ONSITE SEWAGE DISPOSAL SYSTEM

P 554540-13

PROPERTY ADDRESS: 13014 High Grove Road

SCHOOLEY MILL FARM
 SITE PLAN FOR BAT INSTALLATION FOR LOT 9
 13014 HIGHGROVE ROAD
 Zoned: RR-DEO
 Tax Map No. 40; Grid No. 10 & 11; Parcel No. 115 & 149
 Fifth Election District - Howard County, Maryland
 Date: April, 2014 Scale: As Shown

PERMIT PLAN
 LOT 10
 SCHOOLEY MILL FARM

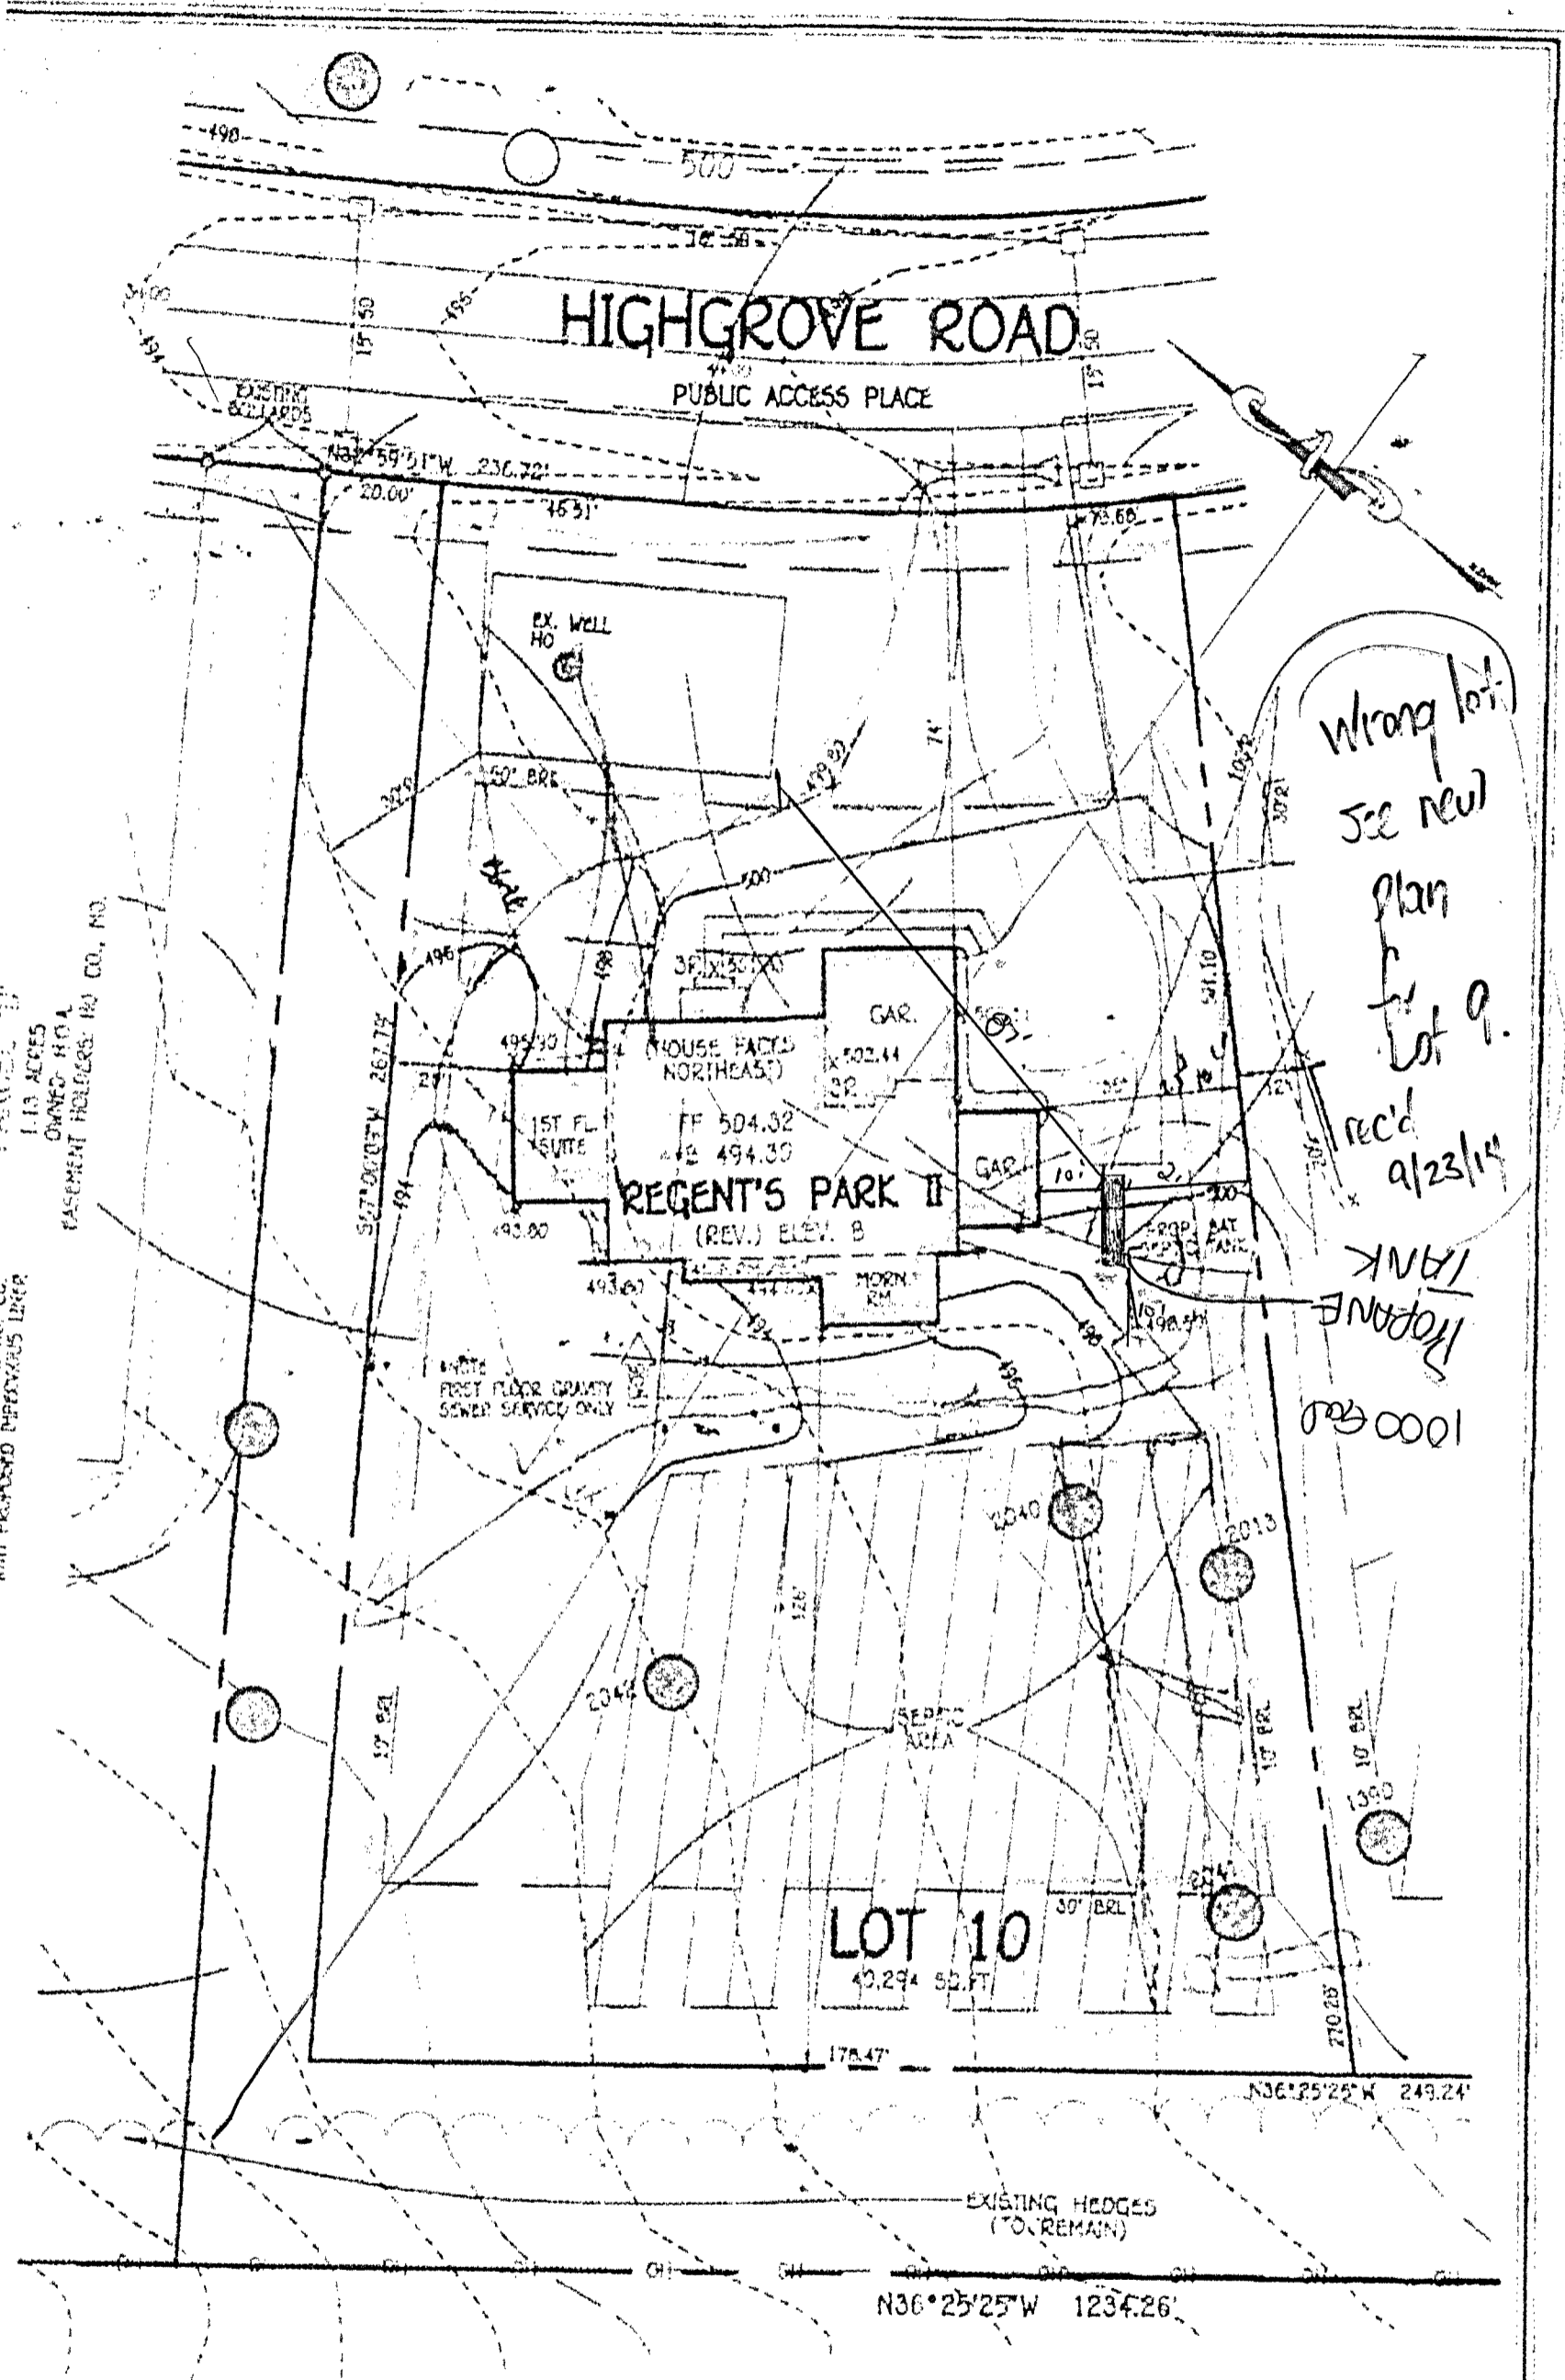
Wrong lot
 See real
 plan
 for
 Lot 9.
 rec'd
 9/23/14
 PROANE
 1000 GAL
